UNLESS OTHERWISE SPECIFIED DIMENSIONS ARE IN INCHES TOLERANCES	
DECIMALS .XX ± .05 .XXX ± .01	ANGULAR ± 0.5 DEG.
DRAWN S. PERKINSON	DATE 03/19/13
CHECKED	SIZE A
DESIGN FOR:	DWG NO. WIRE-MTFGB6-EFV-PSV-LAY-02

AUTOMATIC FILTERS, INC. 2672 S. LA CIENEGA BLVD. LOS ANGELES, CA 90034 (310) 839-2828 FAX (310) 839-6878	
TITLE WIRING LAYOUT FOR MTF FILTER WITH GB6 CONTROLLER, ELECTRIC BALL FLUSH VALVE, SOLENOID VENT FOR PISTON, & ELECTRIC BALL PRESSURE SUSTAINING VALVE	
NOT TO SCALE	REV 2
SHEET 1 OF 1

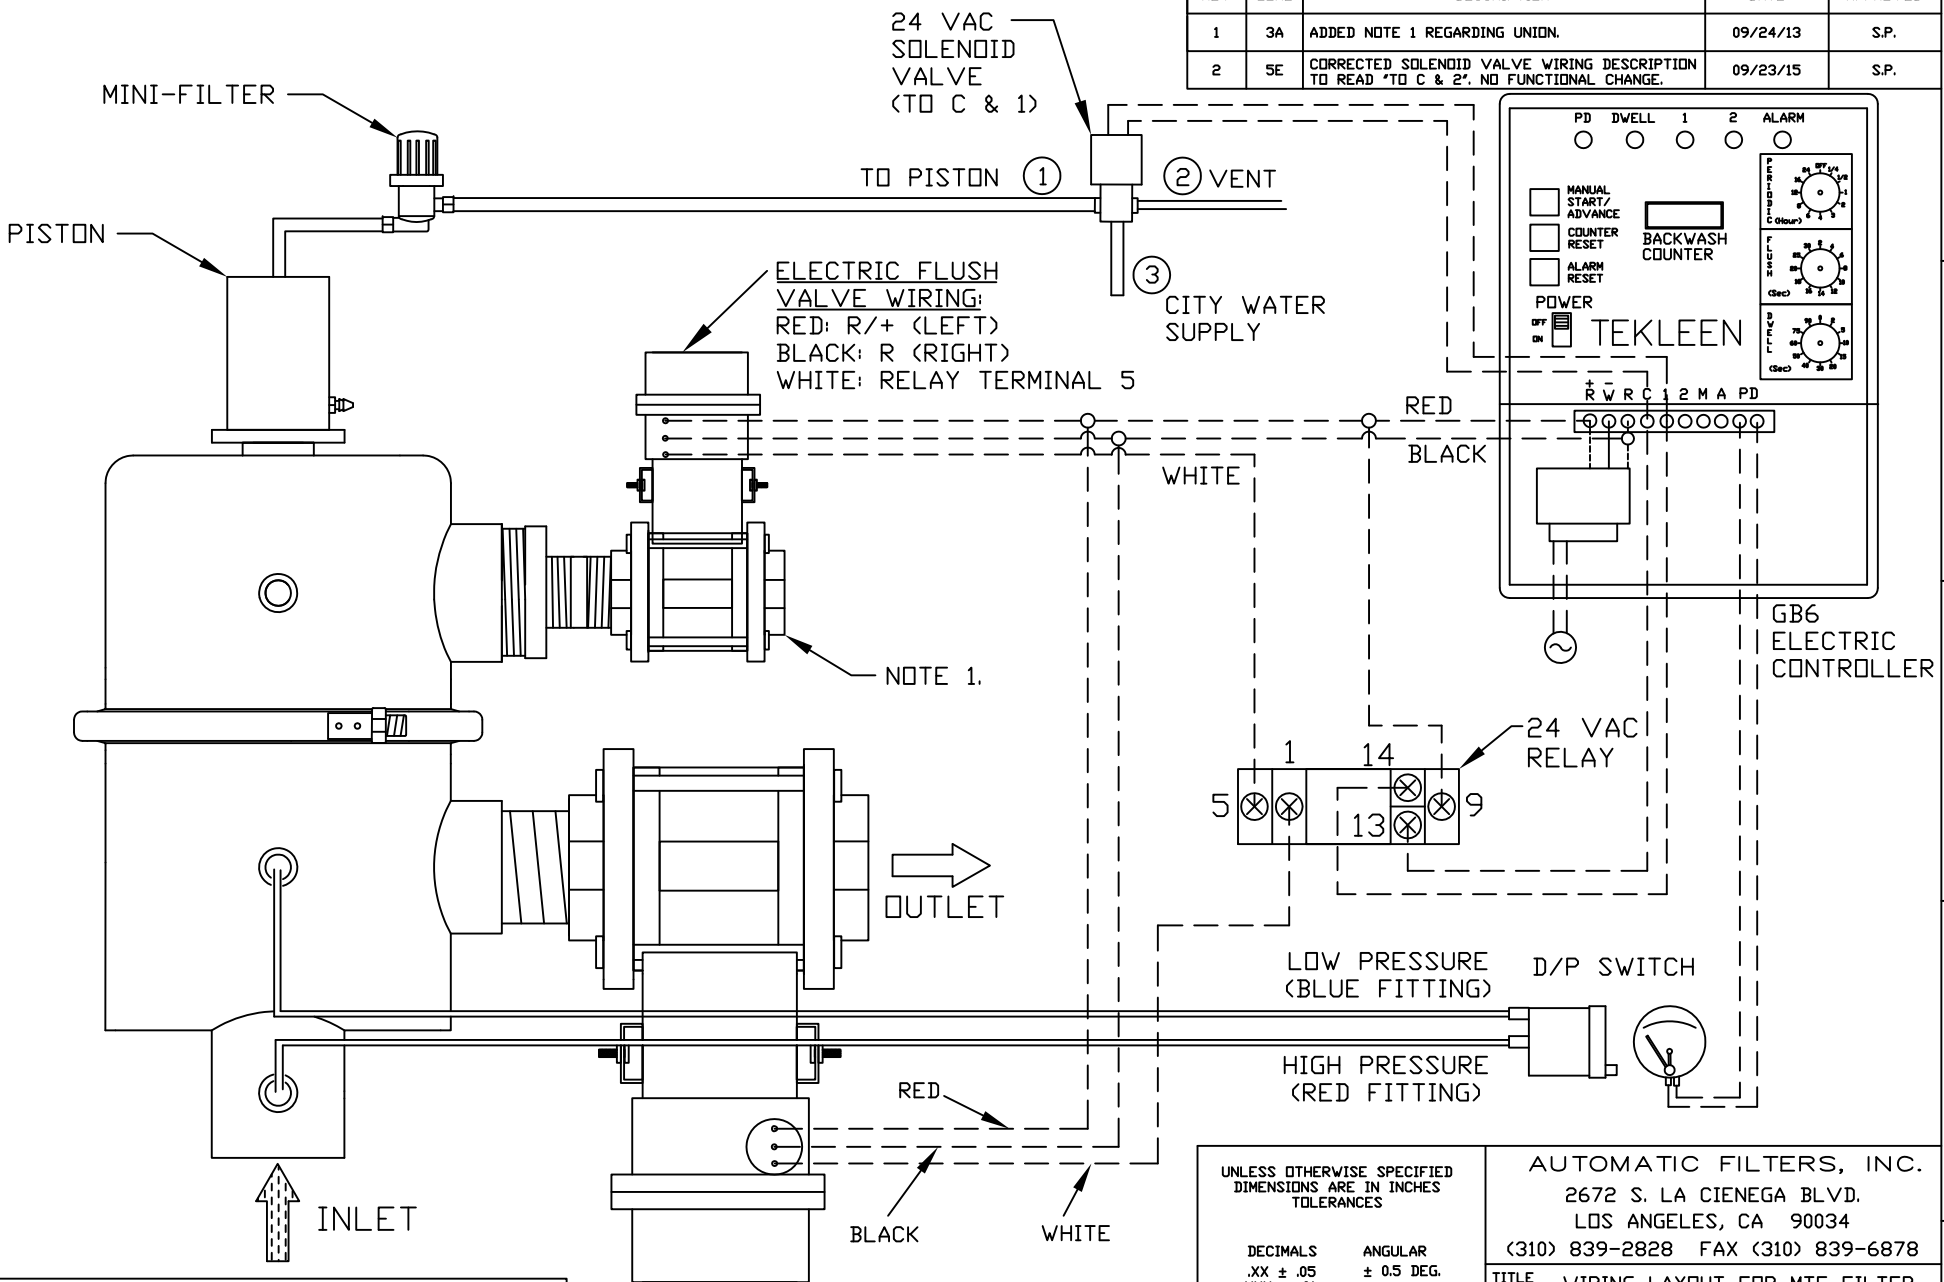
3	ALL	MOVED PSV TO RELAY TERMINAL 1. MOVED EFV TO TERMINAL 1. MOVED SOLENOID TO TERMINAL 1.	09/15/17	R.L.
---	-----	---	----------	------

REVISIONS				
REV	ZONE	DESCRIPTION	DATE	APPROVED
1	3A	ADDED NOTE 1 REGARDING UNION.	09/24/13	S.P.
2	5E	CORRECTED SOLENOID VALVE WIRING DESCRIPTION TO READ 'TO C & 2'. NO FUNCTIONAL CHANGE.	09/23/15	S.P.
